# UNITED STATES PATENT AND TRADEMARK OFFICE

APPLICATION NO.	FILING DATE	FIRST NAMED INVENTOR	ATTORNEY DOCKET NO.	CONFIRMATION NO.
10/797,663	03/09/2004	Michael E. Daniels	4001-0018B (ZM0602)	3929

**Office Action Summary**

## **DETAILED ACTION**

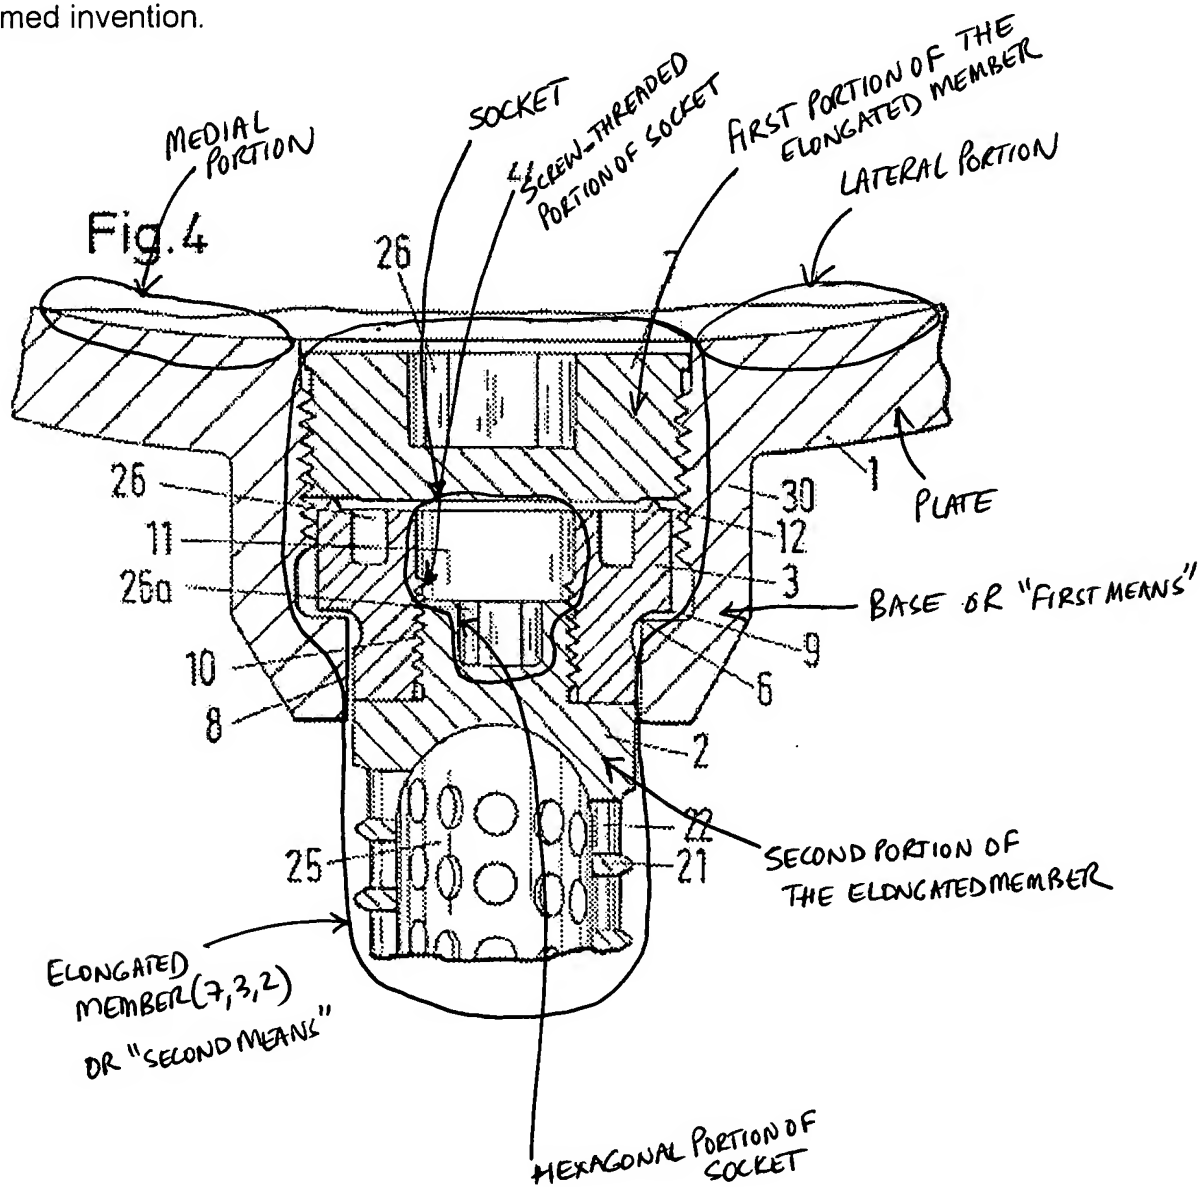
Claims 1, 3, 4, 8-11 and 19 are rejected under 35 U.S.C. 102(b) as being anticipated by Sutter et al. (US 6,102,951).

Sutter et al. disclose a tibial implant apparatus including: a shell or "plate" 1; a projection or "base" or "first means" 30 extending from the tibial plate; an anchoring element or "elongated member" or "second means" (7, 3, 2) including a first portion 7 and a second portion 2; a through passage or "channel" in the tibial plate and the base wherein the through-channel removably receives a first portion 7 of the elongated member from a point superior to tibial plate 1 and the second portion 2 of the elongated member extends away from base 30 (Fig. 4, col. 1, lines 17-23, col. 2, lines 31-55, and col. 3, lines 41-56). See Fig. 4 from Sutter et al. below, marked up to show elements of Applicant's claimed invention.

Sutter et al. disclose a tibial plate 1, a base 30 extending from the plate, and a socket defined in the elongated member (7, 3, 2) wherein the socket includes a hexagonally-shaped portion and a screw-threaded portion. See previous discussion of Sutter et al. and marked up Fig. 4 on page 6 of this action.

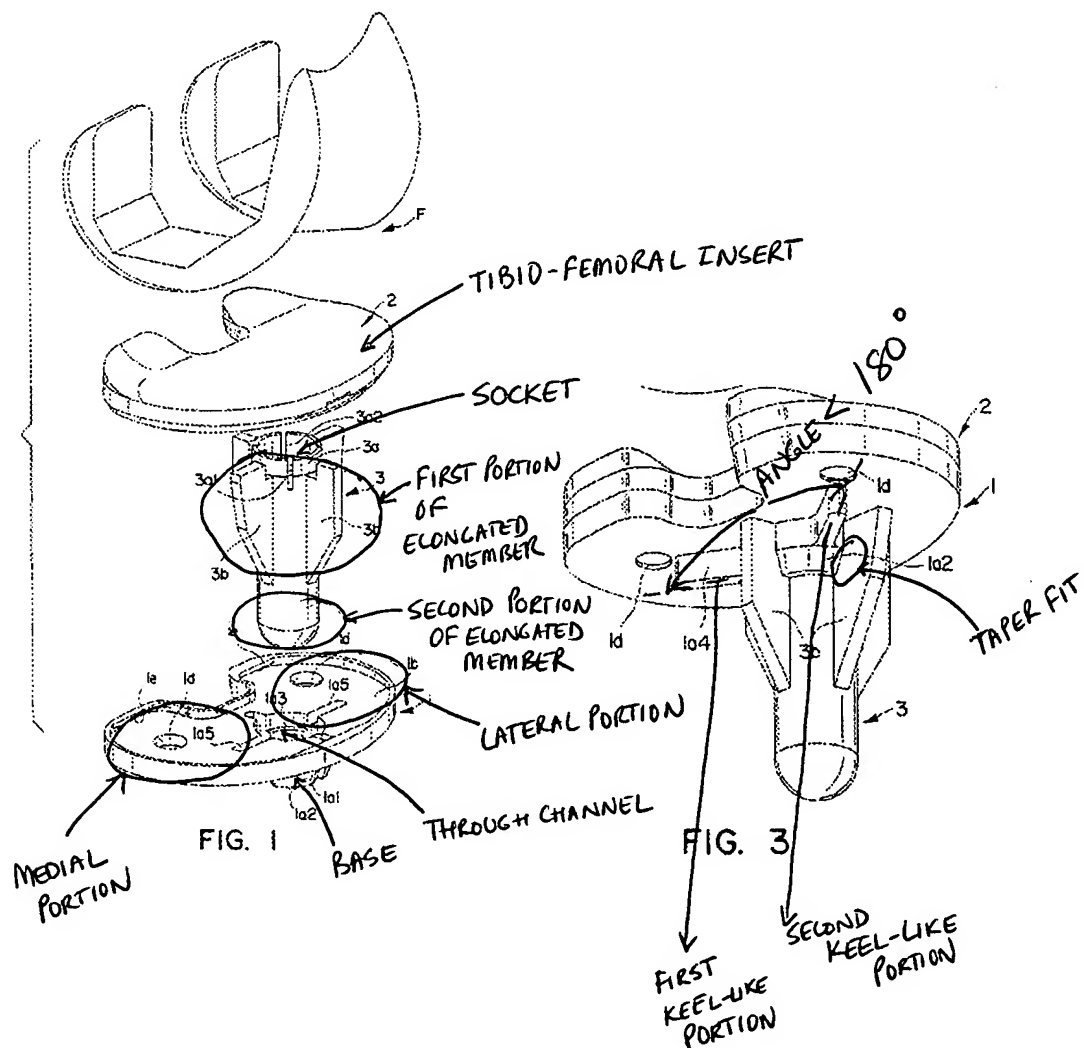
Claims 1-6, 8-9, 11-14 and 19-23 are rejected under 35 U.S.C. 102(b) as being anticipated by Delfosse (US 5,658,341).

Delfosse discloses a tibial implant apparatus including: a tibial socket or "plate" 1 having medial and lateral portions 160; a base 1a1 extending from the tibial plate; a stabilizing pin or "elongated member" 3 including a first portion and a second portion; a through passage or "channel" 1a in the tibial plate and base wherein the through-channel removably receives a first portion of the elongated member from a point superior to tibial plate 1, and the second portion of the elongated member extends away from the base; a tibial plate or "tibio-femoral insert" 2 coupled to the tibial plate 1 (Figs. 1 and 3, col. 2, lines 34-67 and col. 3). Also see Figs. 1 and 3 of Delfosse marked up below to illustrate features of Applicant's invention.

Regarding claims 5 and 12, Delfosse discloses base 1a2 to have first and second keel-like portions or "protuberances" 1a4 that extend radially outwardly relative to the through channel (col. 2, lines 50-51 and marked up Fig. 3 above).

Delfosse discloses all elements of the claimed invention except for an explicit reference to the angle between the first and second keel-like portions to be "about 180 degrees." See marked up Fig. 3 of Delfosse on page 7 of this action suggesting an angle less than 180 degrees between the first and second keel-like portions.
